**Revision to a Request for Supply
Arrangement - Révision à une demande
pour un arrangement en matière
d'approvisionnement**

Title - Sujet Furniture for Work Spaces	
Solicitation No. - N° de l'invitation E60PQ-140003/A	Date 2015-07-31
Client Reference No. - N° de référence du client E60PQ-140003	Amendment No. - N° modif. 021
File No. - N° de dossier pq416.E60PQ-140003	CCC No./N° CCC - FMS No./N° VME
GETS Reference No. - N° de référence de SEAG PW-\$\$PQ-416-66821	
Date of Original Request for Supply Arrangement 2015-02-19 Date de demande pour un arrangement en matière d'app. originale	
Solicitation Closes - L'invitation prend fin at - à 02:00 PM on - le 2015-08-27	
Address Enquiries to: - Adresser toutes questions à: Clouthier, Chantal	Buyer Id - Id de l'acheteur pq416
Telephone No. - N° de téléphone (819) 956-7184 ()	FAX No. - N° de FAX () -
Delivery Required - Livraison exigée	
Destination - of Goods, Services, and Construction: Destination - des biens, services et construction:	
Security - Sécurité This revision does not change the security requirements of the solicitation. Cette révision ne change pas les besoins en matière de sécurité de l'invitation.

This amendment is raise

Historic panel configuration:

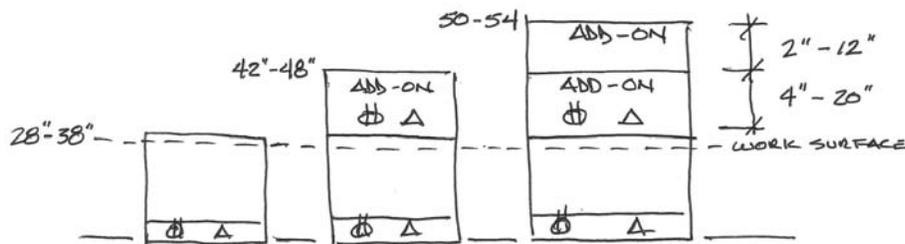
The definition of stack as it applies to the desk height privacy and seated height privacy continues to be a contentious issue.

All major systems furniture tender over the last couple of years (5000 plus WP 2.0 stations) were based on a "base panel" of approx 42-44 "with desk height power and comm. plus a seated privacy of 50-54" that included the base panel plus an add-on.

This new SA configuration with a base panel of 28" to 38" plus multiple add-ons is very different. The requirement to stack from this very low base panel is problematic in that the add-on elements can become very small (as little as 4"-8" high) and will not accommodate power and communications. This also becomes an expensive solution in that the vast majority of demand is for seated privacy and as such must be made up of a base panel plus 2 add-ons.

Additionally the current specification (3.12) requires all add-ons to be load bearing. Most manufacturers only allow the first add-on to be load bearing.

A base panel height of 28"-38" has very limited use. It could be used in perimeter applications but is not necessary given the addition of freestanding elements under the SA. Desking products would also negate its requirement.

A.235:

This specification for Annex A-1, Work Spaces, supports the furniture requirement for the four worker profiles found in general purpose office space as detailed in the latest Government of Canada Workplace 2.0 – Fit-up-Standards – 2012. Category 1 - Interconnecting Panel System must be flexible to accommodate the design of spaces for “Fixed, Flexible and Free Address” worker. In order to achieve our mandate we require panel heights as stated in Annex A-1 article 3.4.

Please refer to section 2 – modifications of this amendment.

Proposed panel configuration:

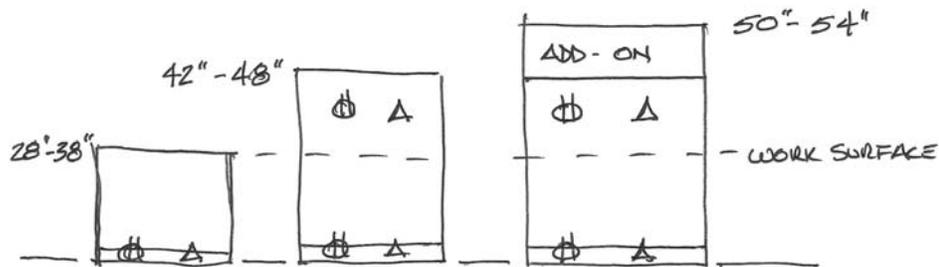
Current SA requested configuration:

So as to include a larger selection of manufacturers in the systems furniture category 1, the description around panel height must be addressed.

The most effective solution would be to keep the current panel heights of 28" to 38", 42" to 48" and 50" to 54".

The 42" to 48" could accommodate base or desk height power and communications. The 50" to 58" height panel would be made up of a 42" to 48" base panel plus an add-on.

This would allow substantially all suppliers to qualify, reduce overall costs while still allowing flexibility.
